# **Groundwater Application Review Summary Form**

Application # G- <u>19335</u>
GW Reviewer Phillip I. Marcy Date Review Completed: 09/28/2023
Summary of GW Availability and Injury Review:
Groundwater for the proposed use is either over appropriated, will not likely be available in the amounts requested without injury to prior water rights, OR will not likely be available within the capacity of the groundwater resource per Section B of the attached review form.
Summary of Potential for Substantial Interference Review:
$\square$ There is the potential for substantial interference per Section C of the attached review form.
Summary of Well Construction Assessment:
☐ The well does not appear to meet current well construction standards per Section D of the attached review form. Route through Well Construction and Compliance Section.
This is only a summary. Documentation is attached and should be read thoroughly to understand the basis for determinations and for conditions that may be necessary for a permit (if one is issued).

MEM	O							_5	Septemb	er 28, 2	023_	
TO:		Applica	tion G-	19335	-							
FRON	И:	<b>GW:</b> <u>P</u>	<b>hillip I. I</b> Reviewer									
SUBJ	ECT: S	Scenic Wa

### Water-Level Measurements in Nearby Wells

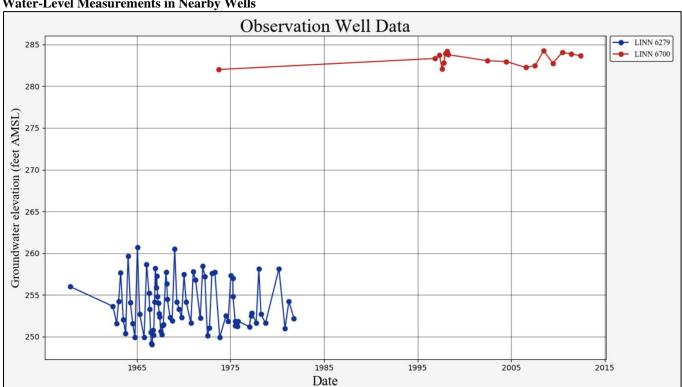
c.	☐ Condition to allow groundwater production only from the groundwater reservoir between approximately ft. and ft. below land surface;
d.	☐ <b>Well reconstruction</b> is necessary to accomplish one or more of the above conditions. The problems that are likely to occur with this use and without reconstructing are cited below. Without reconstruction, I recommend withholding issuance of the permit until evidence of well reconstruction is filed with the Department and approved by the Groundwater Section.
	<b>Describe injury</b> —as related to water availability— that is likely to occur without well reconstruction (interference w/ senior water rights, not within the capacity of the resource, etc):
	undwater availability remarks: There is little groundwater level data in the area surrounding the proposed POA wells available data display trends suggesting that groundwater elevations are stable within the alluvial aquifer system.
